VALIDATION REPORT

PROJECT FOR THE REDUCTION OF GREENHOUSE GAS EMISSIONS OF HIDROELECTRICA LA CONFLUENCIA S.A. IN CHILE

REPORT No. 2010-0270

DET NORSKE VERITAS

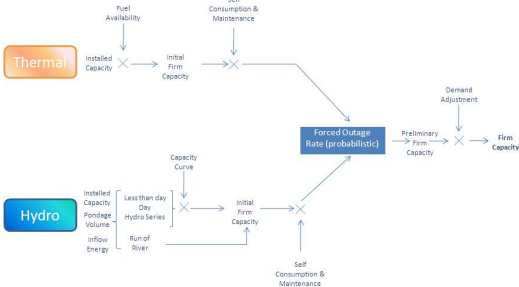
Corrective action and/ or clarification requests	Reference to Table 2	Response by project participants	Validation conclusion
		seia.cl/documentos/documento.php?idDocumento=2292756 -) RCA 64 2009 -) RCA 68_09 -) RCA 120-2009 -) RCA 122_2008 -) RCA 192-2009 -) RCA 219 -) RCA 236 -) RCA N°30 2009	
<p>CAR 2</p> <p>The project proponent is requested to verify the total installed capacity given that:</p> <ul style="list-style-type: none"> a) in Tables 2 and 6 of the PDD /1/ (pp 7 & 15 respectively) it says 160 MW; b) while in the IFC investment memorandum /11/ (pp x, 21, 23 & 31) it is written 158 MW; c) and in the 3rd Article of the EIA Approval /9/, general characteristics of the project (pp 3), it is specified the range of 145 – 155 MW. <p>The PDD shall be updated, or evidence shall be presented to justify the difference.</p>	A.2.4 A.2.6 B.5.23 B.5.24 B.5.25	<p>a) Supplier informed a total installed capacity of: 81.61 MW each turbine, it is, a total of 163.22 MW for the plant. Capacity informed is given by the design hydraulic conditions, which are:</p> <ul style="list-style-type: none"> • Net head (nominal): 335.1 m • Rated Flow: 26.25 m³/s <p>Installed Capacity is theoretical, and responds to a design issue. <u>Real capacity</u> in this and any other hydraulic point will be verified in the field with tests.</p> <p>b) In the real scale, if estimation (a value) is required before any field verification (which is now the case), it must be given mentioning where the output is “measured”. Indeed, there are at least three different outputs to be informed under such case. They are:</p> <ul style="list-style-type: none"> • Turbine Shaft output (hydraulic torque, 	<p>Although at the design phase all values are theoretical, the equipment supplier normally guarantees a minimum output based on a given set of conditions, which sometimes are referred to as nominal values. Such values are then verified through tests run after commissioning to ensure that the equipment does deliver at least the minimum output at the nominal values.</p> <p>The guaranteed efficiency provided by the equipment supplier is calculated as a mean weighted efficiency for a range of net heads (335.1 to 343.1 m) and set of corresponding flows /39/. According to this the turbine efficiency will be not less than 93.92%. However for the effects of the project activity the PP has chosen to use the specific efficiency determined by the equipment supplier for ht nominal head value, namely, 94.9% at 335.1 m head with</p>

Corrective action and/ or clarification requests	Reference to Table 2	Response by project participants	Validation conclusion
		<p>converted in mechanical torque, less mechanical losses, which is the indicated in a),</p> <ul style="list-style-type: none"> • At the generators terminals (must include turbine and generator efficiencies and all mechanical and electrical losses up to) and, • At the main step up transformers terminals (including efficiencies and all mechanical and electrical losses of all power train) <p>c) Therefore, due that today, field test have not been performed yet, only an estimation starting from the design conditions could be made. It is:</p> <p>HPA: Hydraulic power available: ($\gamma * Q * H_n$), where:</p> <ul style="list-style-type: none"> ✓ γ: water density ✓ Q: flow turbined ✓ H_n: Net head (include hydraulic losses) <p>Minimum = 329.3 m Nominal = 335.1 m Maximum = 346.0 m</p> <p>Doing the calculus for nominal case, we have:</p>	<p>a 26.25 m³/s flow /39/.</p> <p>Based on the guaranteed efficiency the output power at the generator is then calculated as follows:</p> <p>HPA = Hydraulic power available, and, Turbine output (O_T) = HPA – losses and, Generator output (O_G) = O_T – losses</p> <p>Thus: HPA = $\gamma * Q * H_n$, where:</p> <ul style="list-style-type: none"> • γ: water density (1000 kg/m³) • Q: flow turbined (26.25 m³/s) • H_n: Net head (include hydraulic losses). Nominal = 335.1 m <p>HPA = 86.4 MW and, given that the losses applied to the turbine are: turbine efficiency, η_t (94.9%) and turbine guide bearing losses, TBG (0.333MW), then:</p> <p>$O_T = 86.4 \text{ MW} * 0.949 - 0.333 \text{ MW}$ $O_T = 81.61 \text{ MW}$</p> <p>$2 * 81.61 \text{ MW} = 163.22 \text{ MW}$</p>

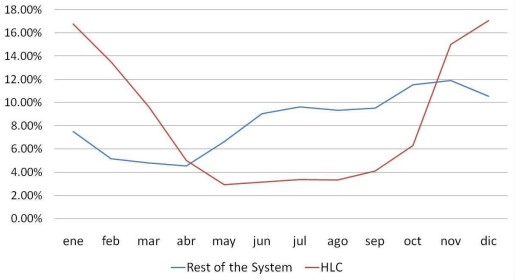
Corrective action and/ or clarification requests	Reference to Table 2	Response by project participants	Validation conclusion
			This CAR (CAR 4) continues below.
<p>CAR 4 (continued)</p> <p>The PP is required to :</p> <p>1) clarify/rephrase the following sentence: “It is worth to mention that this bylaw is not has been officially enacted but its application upon definition for the ancillary services regulations.”</p> <p>2) Furthermore, the PP is requested to present explicitly the calculations resulting in a value for firm capacity of 112 MW, and that considered the text in the Synex Report /23/, paragraph 3.4, on page 10, and the “Firm Capacity” table shown on page 11.</p> <p>3) Explain the differences between the firm capacity value of 112 MW and those values shown in the other documents provided as reference to the validation.</p>		<p>1) Even though the DS62 bylaw established that the methodology should be applied after the issue of the bylaw itself, in order to maintain coherence with the rest of the regulation, the authority issued DS44/2007 that modified the DS62 in order to establish that the first application of the new methodology should be carried out once the “ancillary services” regulations were in force. The methodology is described in section 2.5 of the Synex report.</p> <p>2) The calculation of the firm capacity has been conducted by Synex. The methodology to calculate the firm capacity (now called “adequacy capacity”) as applied by Synex/IFC can be divided in four steps:</p> <p>i) First step: Determination of the initial firm capacity of thermal and hydro power plants (For Hydropower plants, the initial firm capacity is a function of the maximum installed capacity, the inflow energy corresponding to dry hydrological conditions (average of the two driest hydro conditions of the system), pondage volumes and the stored energy at the beginning of the hydrological year. Irrigation constrains are deducted from inflows.)</p> <p>ii) Second step: the initial firm capacity is</p>	<p>DNV has been able to verify that the by law DS62 /36/ and its application amendment as per the decree DS44/2007 /50/, establishes a general methodology for the calculation of the firm capacity. Based on this, and as part of the project activity the PP and IFC requested the chilean company Synex /36/ to estimate the firm capacity to be considered in the project activity in accordance to the methodology specified in the bylaws DS62 /36/ and DS44/2007/50/.</p> <p>DNV has found that the evidence presented for validation sufficiently addresses the issue raised.</p> <p>Therefore this CAR is closed</p>

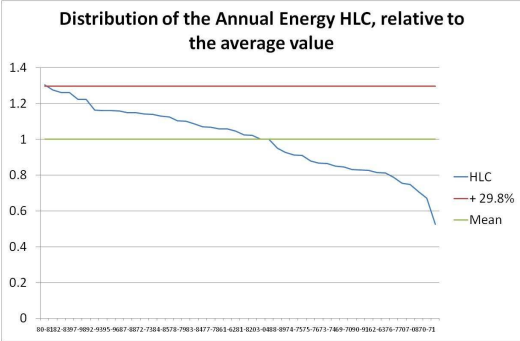
Corrective action and/ or clarification requests	Reference to Table 2	Response by project participants	Validation conclusion
		<p>reduced, according to the scheduled maintenance periods and self consumption</p> <p>iii) Third step: take into account the forced outage rate of each power plant through a convolution model. This result is called preliminary firm capacity.</p> <p>iv) Fourth step: the preliminary firm capacities of each plant are adjusted so that the sum of these capacities matches the peak demand. These adjusted firm capacities correspond to the firm capacity of the units.</p> <p>Firm capacity methodology:</p>  <pre> graph TD subgraph Thermal FA[Fuel Availability] --> IC1[Installed Capacity] SC1[Self Consumption & Maintenance] --> IF1[Initial Firm Capacity] IC1 --> IF1 IF1 --> FOCR[Forced Outage Rate probabilistic] end subgraph Hydro IE[Inflow Energy] --> RV[Run of River] RV --> LDD[Less than day] LDD --> HVS[Hydro Series] HVS --> IC2[Installed Capacity] SC2[Self Consumption & Maintenance] --> IF2[Initial Firm Capacity] IC2 --> IF2 IF2 --> FOCR end FOCR --> PFC[Preliminary Firm Capacity] DA[Demand Adjustment] --> FC[Firm Capacity] PFC --> FC </pre> <p>Please find attached a report by Synex explaining in detail how the calculations are done (Potencia de suficiencia 07jun10.pdf; Potencia de suficiencia 07jun10_translation.pdf).</p>
